# Green Hill Solar Farm

## EN010170

### Change Application 2 and Supporting Environmental Information Report

Document Reference: CR2/GH9.6  
The Infrastructure Planning (Examination Procedure) Rules 2010  
Rules 8(1)(c)

## Change Number 1

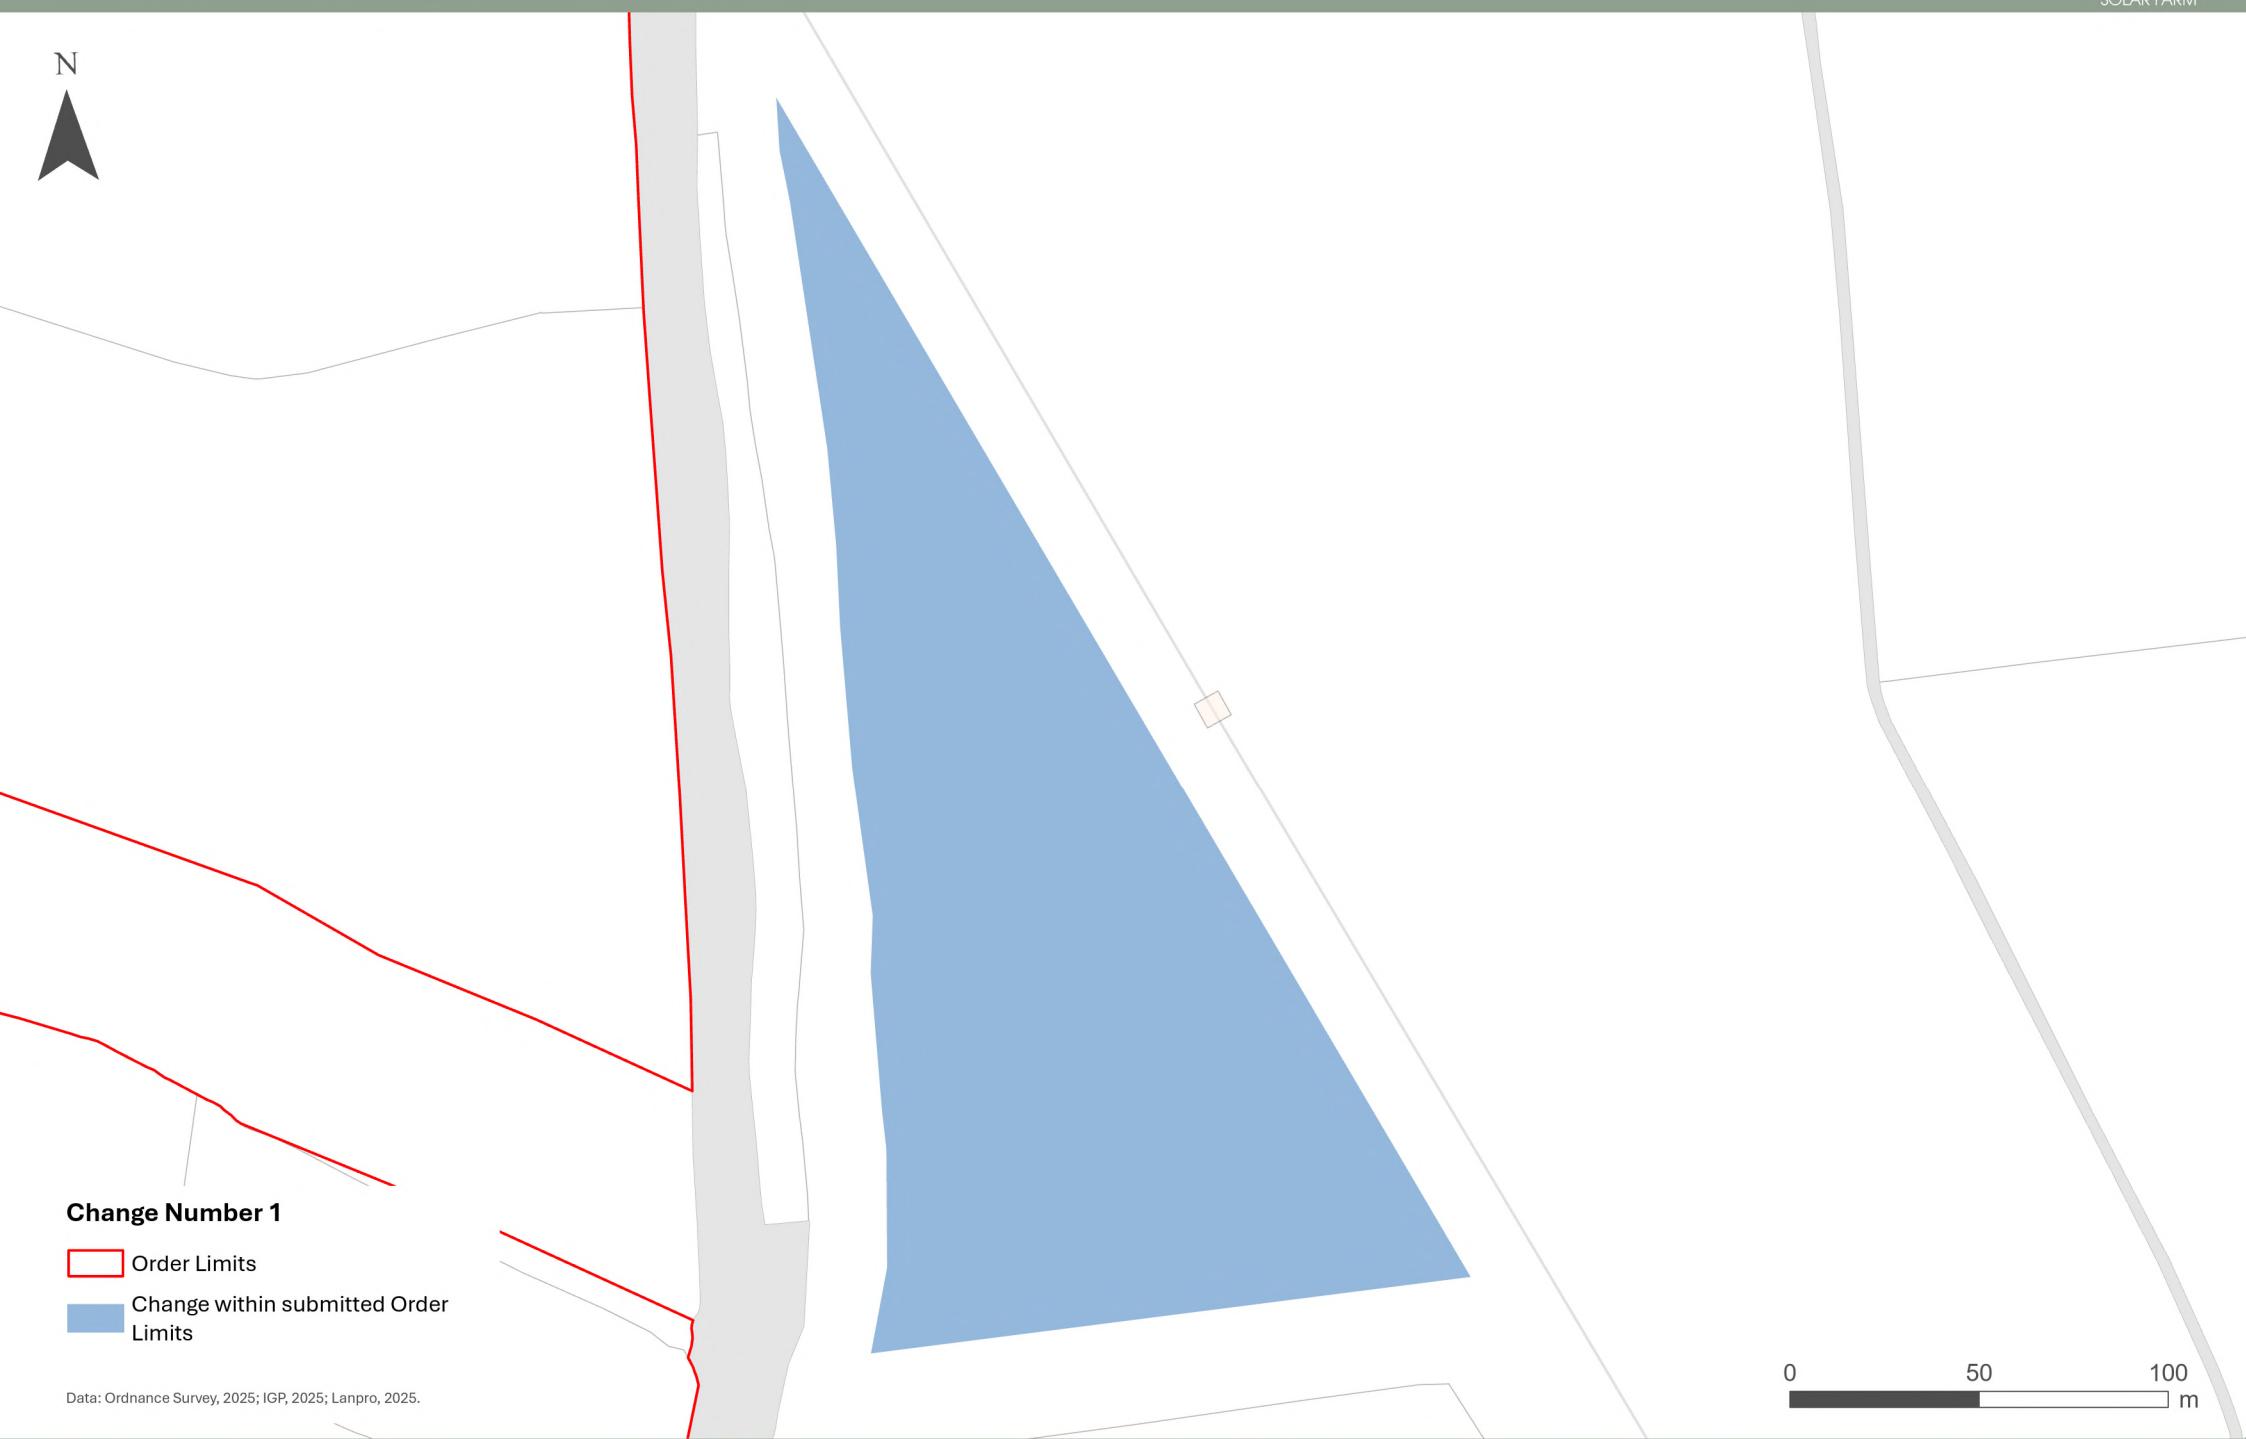
3.2.1 Change One comprises the provision of optionality to allow for a 400 kV substation to be located at Green Hill G. A detailed post-submission review of the Scheme's electrical design undertaken by the Applicant has identified the need for flexibility to allow for either a 132 kV or a 400 kV substation in this location.

3.2.2 The 400 kV substation will be located within the revised area of Work No. 3A of the **Works Plans [CR2/GH2.4\_E]**. This would form 'Option B' for Green Hill G, comprising the removal of panels and the provision of a 400 kV substation. Option A includes a 132 kV substation as originally proposed in the DCO application.

3.3.3 Additional woodland planting will also be provided to the south of field GF3. This planting will provide screening for the 400 kV substation, and will also assist in providing habitat connectivity to the ancient woodland, Barsley Spinney, located to the west of the Green Hill G. This woodland planting would be implemented under 'Option B' only.
